**Modification to Approved Project**  
**City of Rochester, New Hampshire**

Case # 216-8, 9, 10 Property Address 60 Farmington Road

Project name Proposed Commercial Development

**Proposed Commercial Development**  
**60 Farmington Road – Rochester, NH**

OVERALL SITE PLAN

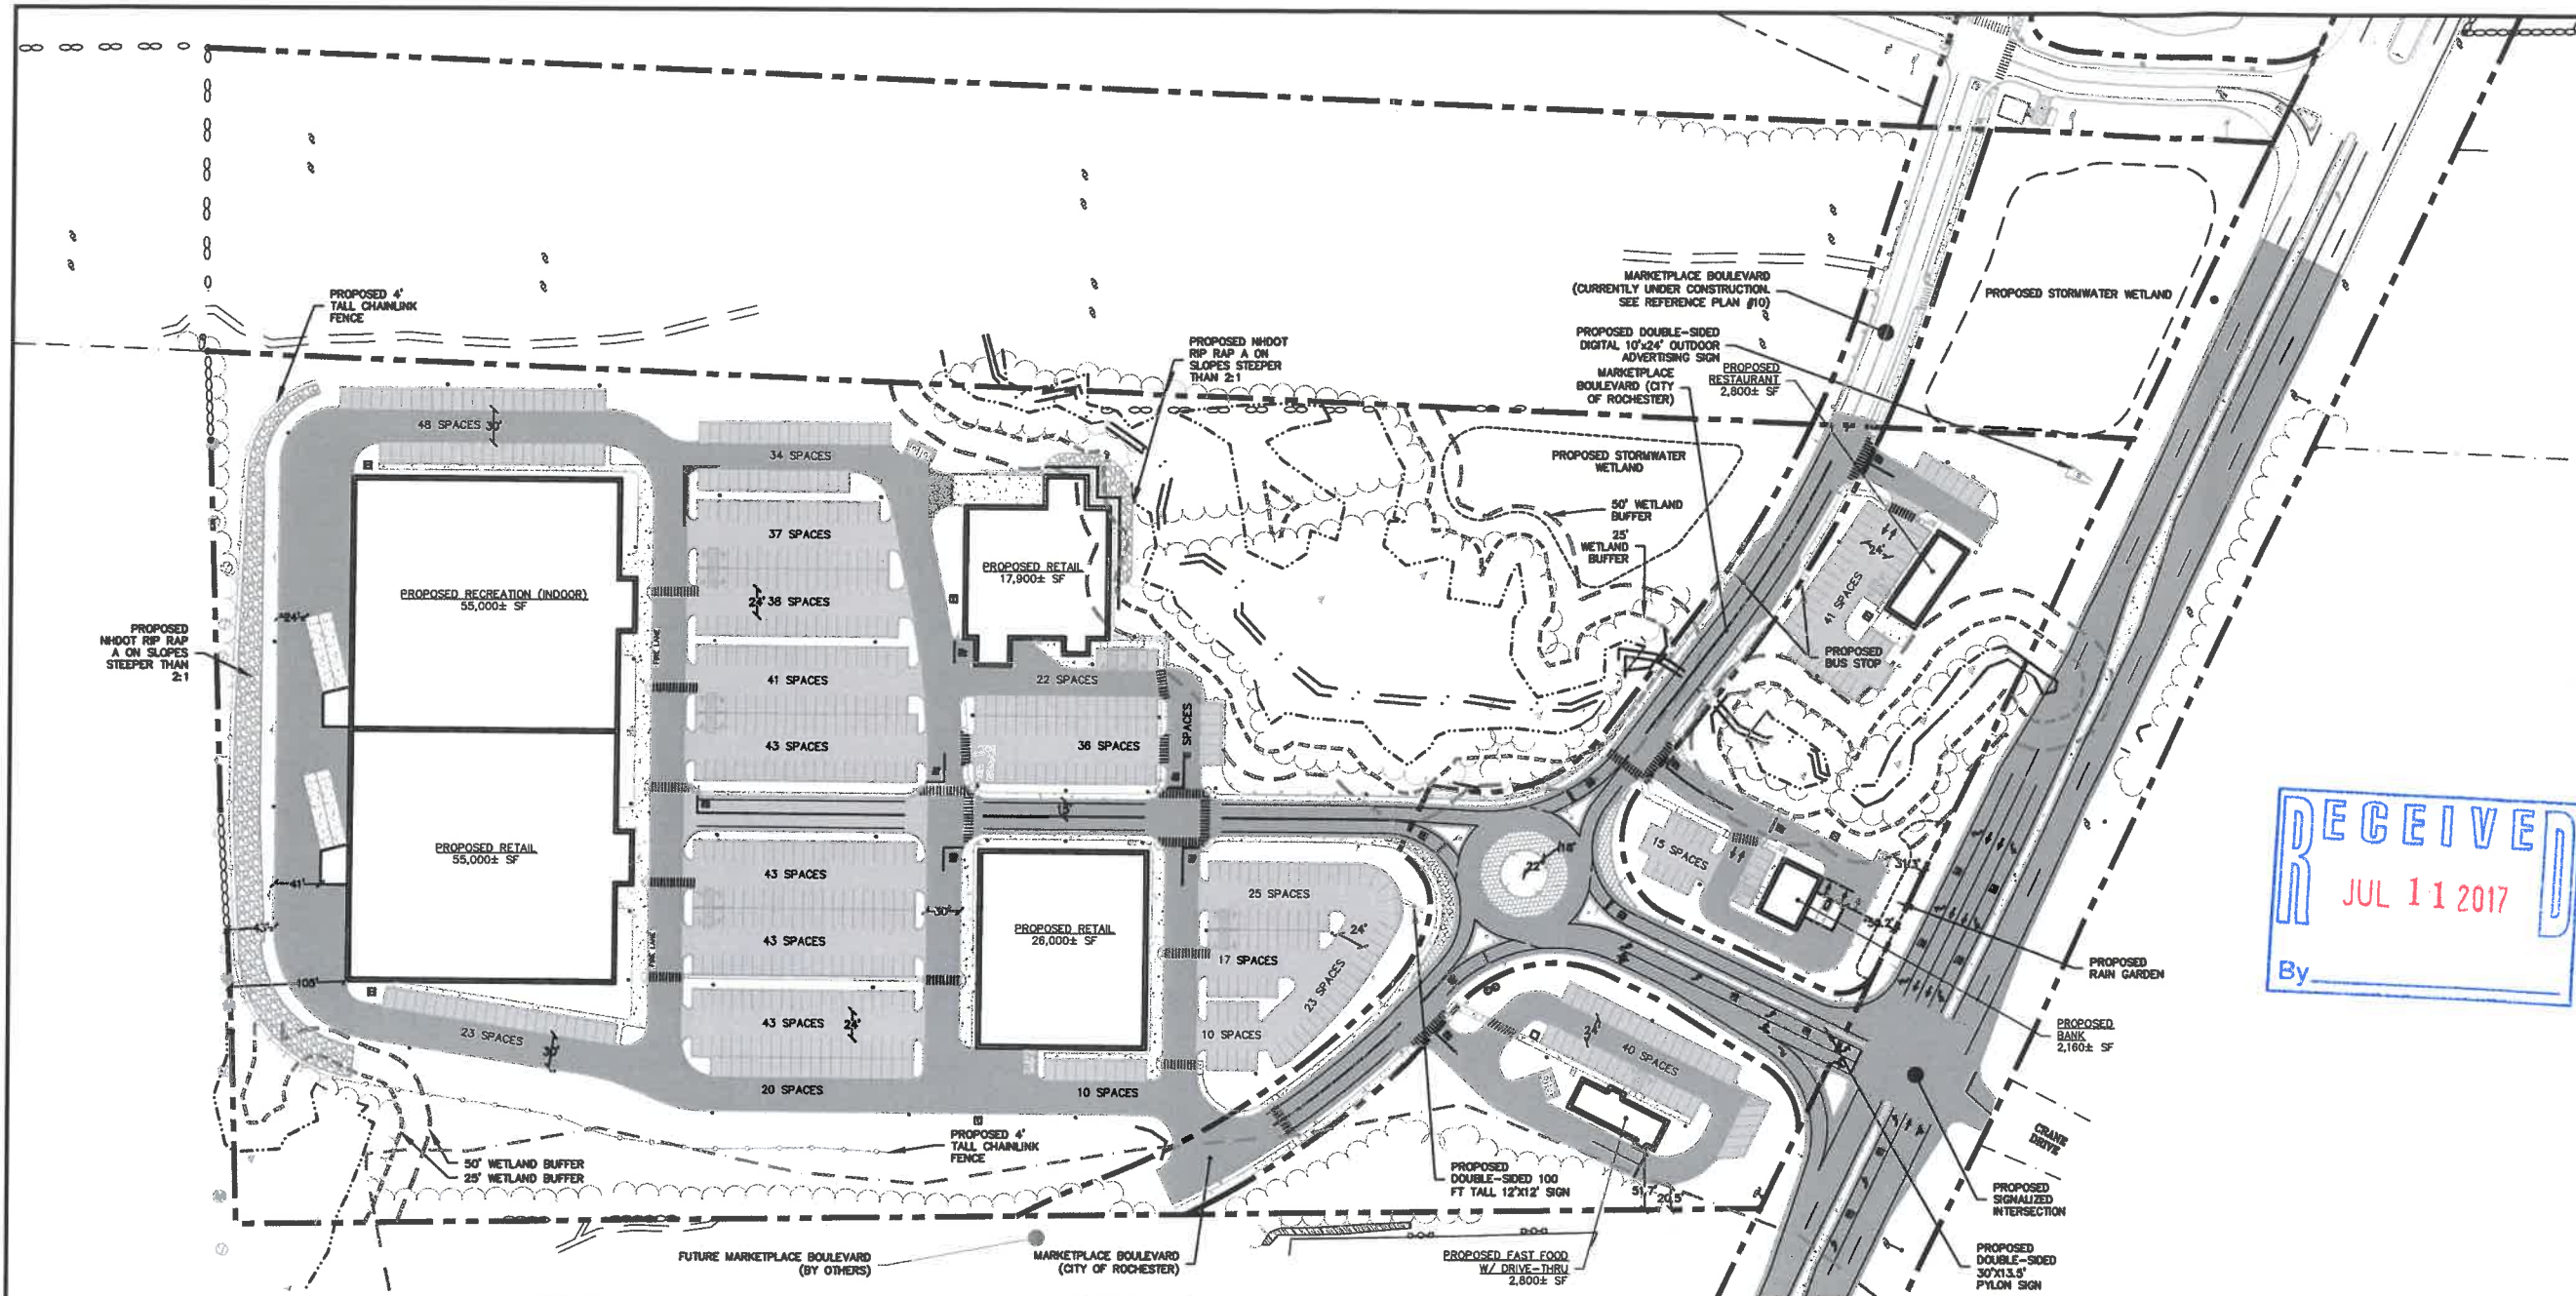
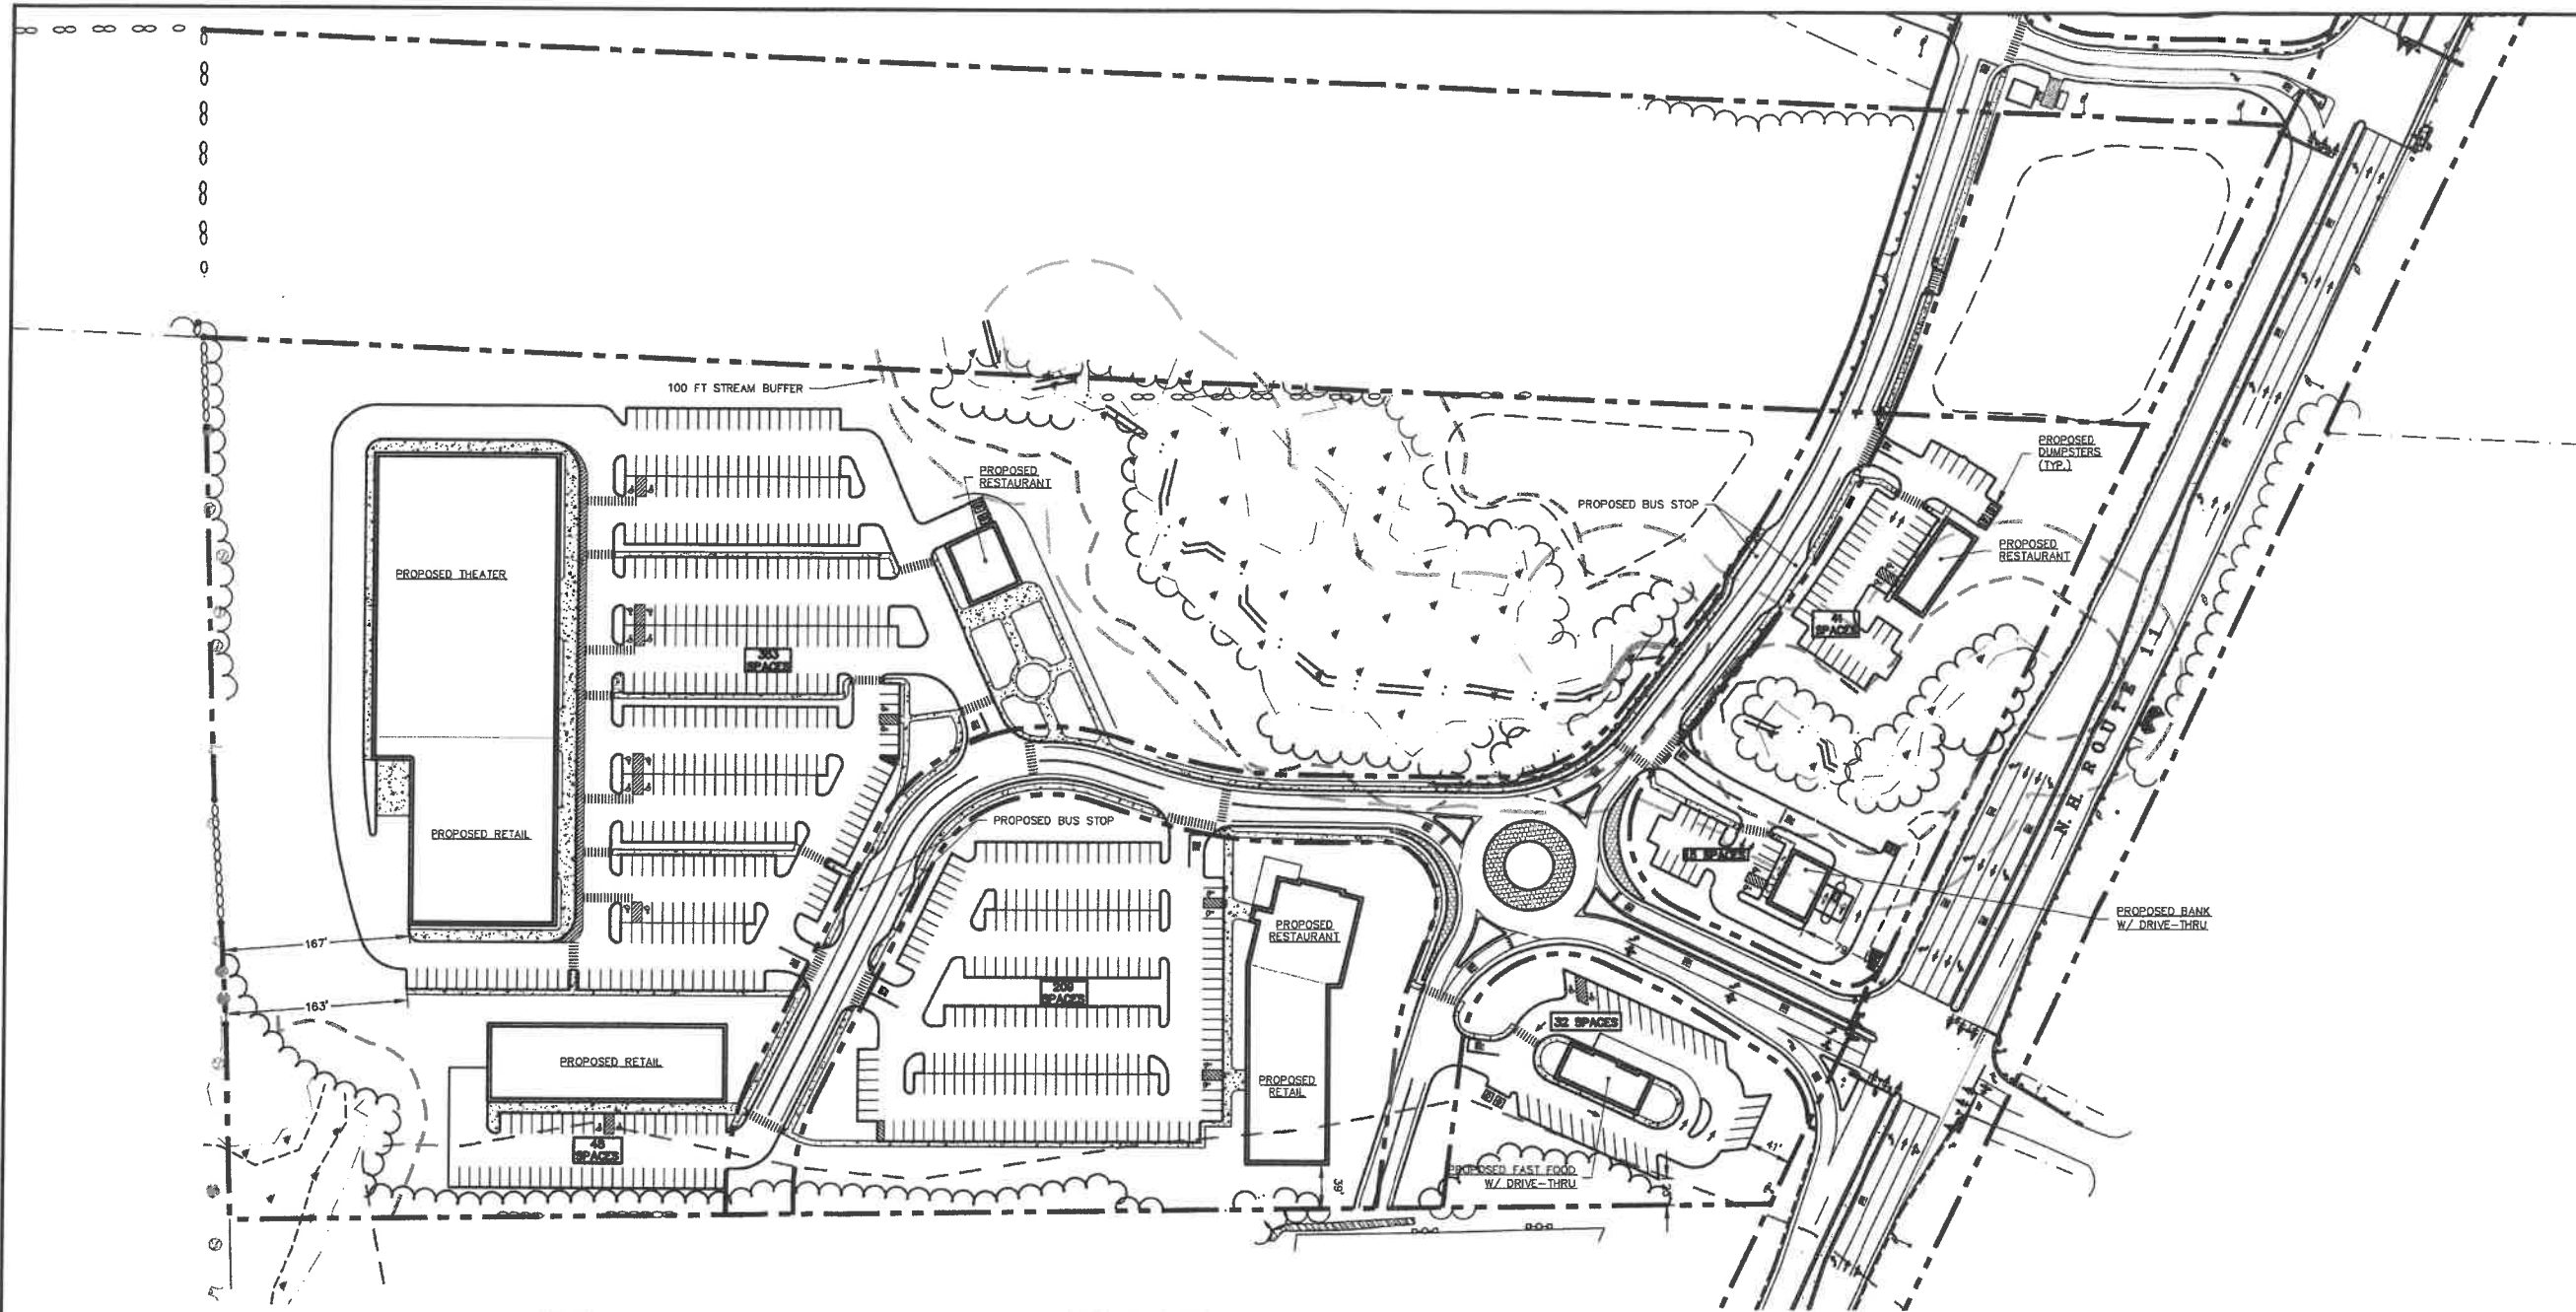
- Building Footprint Changes:
  - o The total proposed building square footage decreased from +/-161,660 sf to +/-110,210 sf because of tenant specific requests and in an effort to reduce wetland impacts.

- o Building footprints have been revised to have more smaller buildings that are connected by pedestrian pathways.
- Parking Lot Revisions:
  - o The total parking proposed increased from 658 to 698 spaces. This provides approximately 6.3 spaces per 1000 sf of GFA. This is an increase from the previously approved design which had 4.07 spaces per 1000 sf of GFA. The increase is due to tenant specific requests for additional parking.

- Wetland Impacts/Stormwater
  - o As noted above, the Applicant has obtained a wetland dredge and fill permit from the NHDES for this revised design. To obtain the permit, the Applicant's design had to reduce the amount of wetland impacts and improve water quality for stormwater runoff.

To provide the improved water quality, the Applicant revised the stormwater management system for the development to include four (4) additional underground infiltration basins, two (2) additional rain gardens, and convert one of the previously approved stormwater wetlands to a gravel wetland. These treatment devices have been located strategically in areas where fill is to be placed due to the presence of ledge at the site.

- o The location of the relocated intermittent stream has been modified to avoid placing the channel in an open bottom culvert. The entire channel will now be an open channel at the rear of the site.

- o A park has been added adjacent to the wetland buffer areas where a parking lot was previously approved.

- o The proposed future City right of way, Marketplace Boulevard, has been extended further south and west through the development in response to feedback received from property abutters. The relocation of this road allows for two additional bus stops in the commercial district (one in each direction) and a road that will cross the abutting property at a more perpendicular angle.

PROPOSED CHANGES  
TO OVERALL SITE  
PLAN

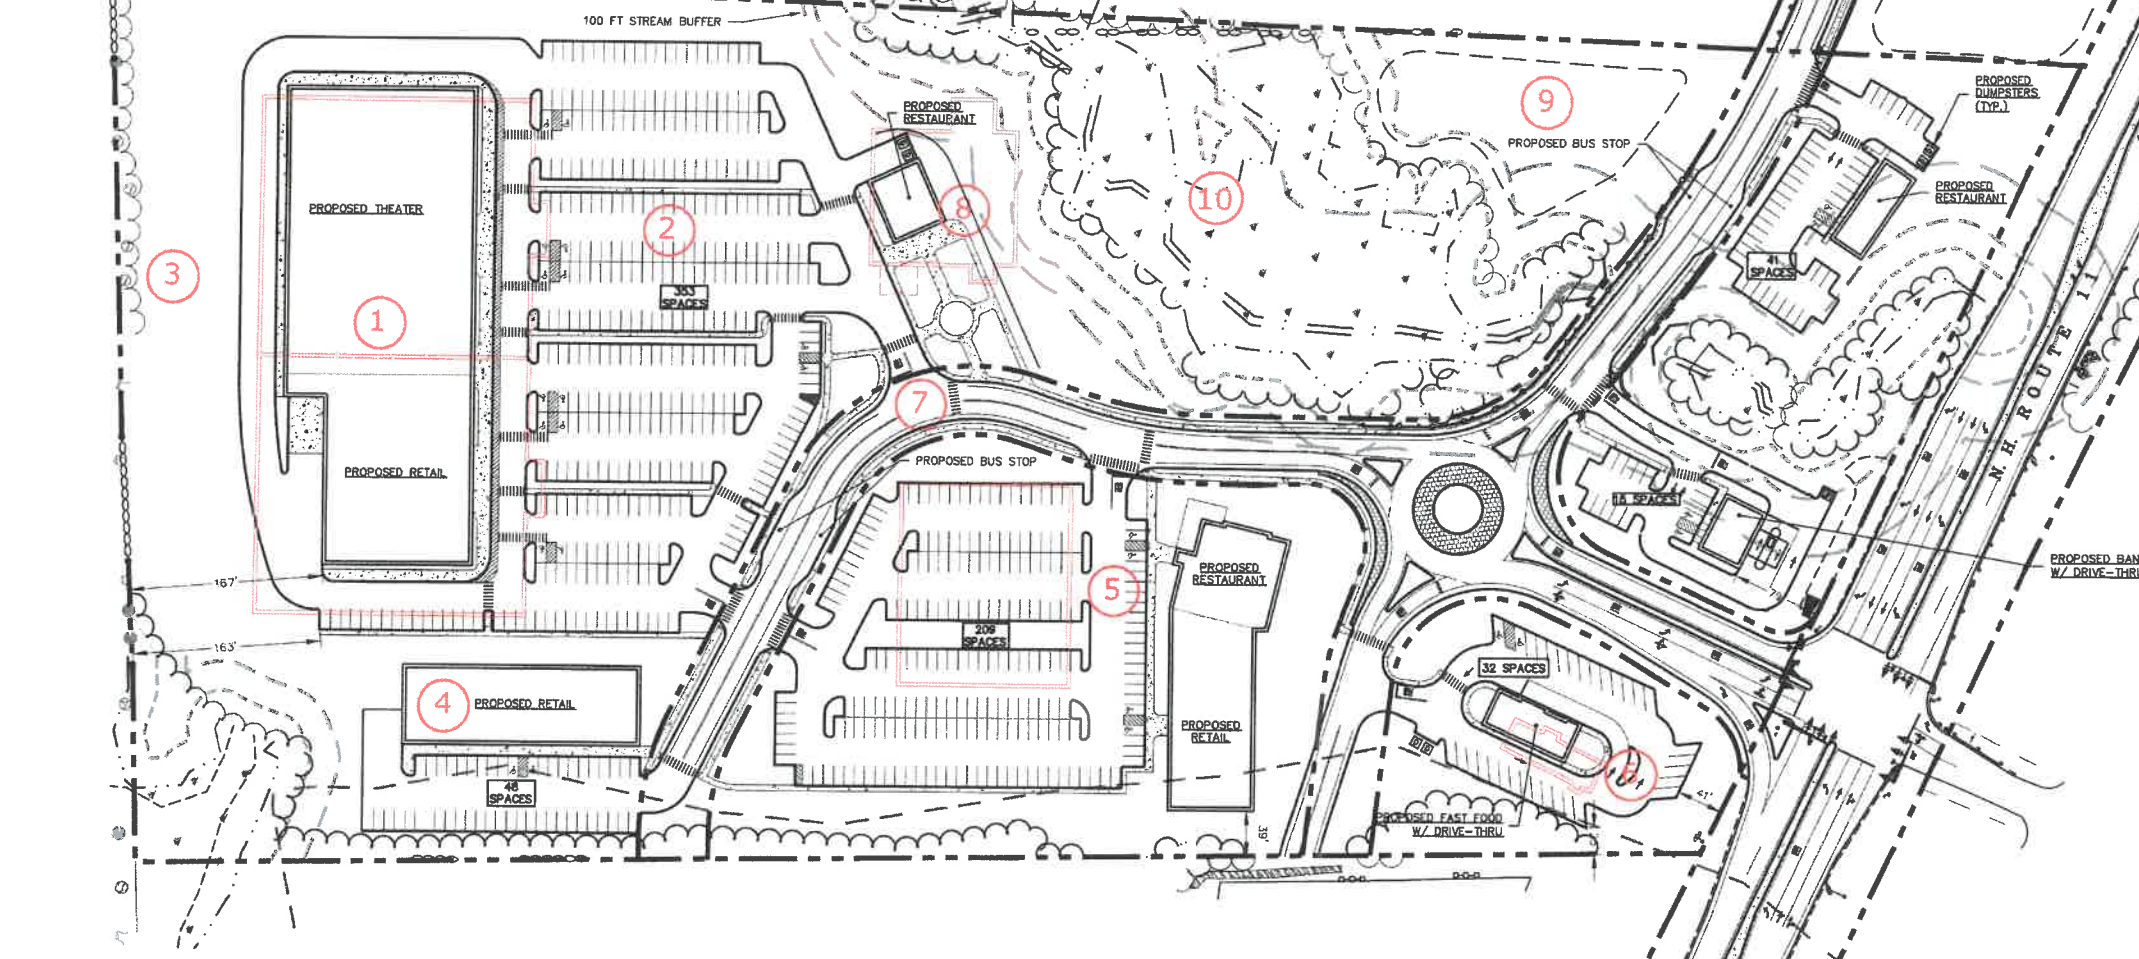
- 1. BUILDING MODIFICATIONS
  - 110,000± SF BUILDING HAS BEEN REDUCED TO TWO BUILDINGS TOTALING APPROXIMATELY 67,000± SF
  - BUILDING USE HAS BEEN REVISED PER TENANT REQUEST

2. PARKING MODIFICATIONS
  - TOTAL PARKING PROPOSED IN THIS AREA HAS DECREASED
  - OVERALL PARKING CONFIGURATION HAS CHANGED
3. RELOCATED INTERMITTENT STREAM RESTORATION AREA

4. NEW BUILDING
  - ADDITION OF 14,700+ SF BUILDING
  - ADDITION OF 48 PARKING SPACES WITH TWO ACCESSIBLE SPACES
5. BUILDING AND PARKING MODIFICATIONS
  - 28,000+ SF PROPOSED RETAIL BUILDING HAS BEEN REDUCED TO TWO BUILDINGS TOTALING APPROXIMATELY 17,200+ SF

6. PARKING MODIFICATIONS
  - PARKING CONFIGURATION HAS BEEN REVISED FOR DRIVE-THRU PER TENANT REQUEST
7. MARKETPLACE BOULEVARD RIGHT OF WAY
  - LIMITS OF FUTURE CITY RIGHT OF WAY HAS BEEN REVISED PER DISCUSSIONS WITH AGUATING PROPERTY OWNERS

8. BUILDING AND SITE MODIFICATIONS
  - 28,000+ SF BUILDING HAS BEEN REDUCED TO 3,000+ SF
  - PARKING LOT HAS BEEN REMOVED AND REPLACED WITH A PARK
9. STORMWATER WETLAND

- STORMWATER WETLAND HAS BEEN CHANGED TO A GRAVEL WETLAND
10. REDUCTION IN WETLAND IMPACTS
